Retained Accessory Power (RAP) Schematics (Cell 15: Door Lock and Side Window Switches)

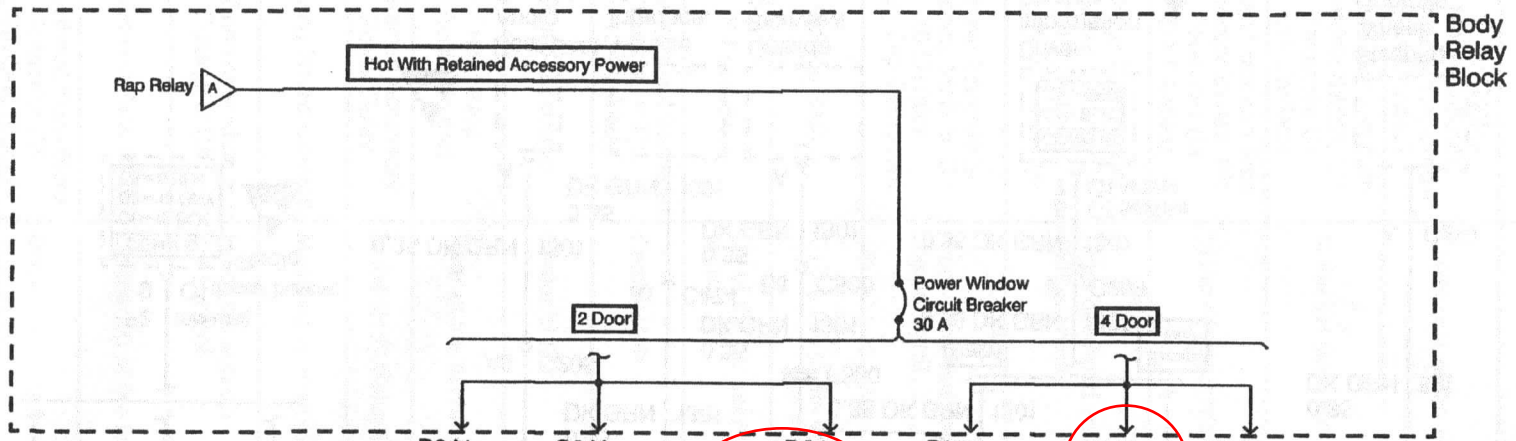
For 4dr Blazer, pin C3 will provide +BATT via RAP.

For 2dr Blazer, pin D3 (likely) will provide +BATT via RAP if no sunroof.

For Pickup: same as for 2dr?
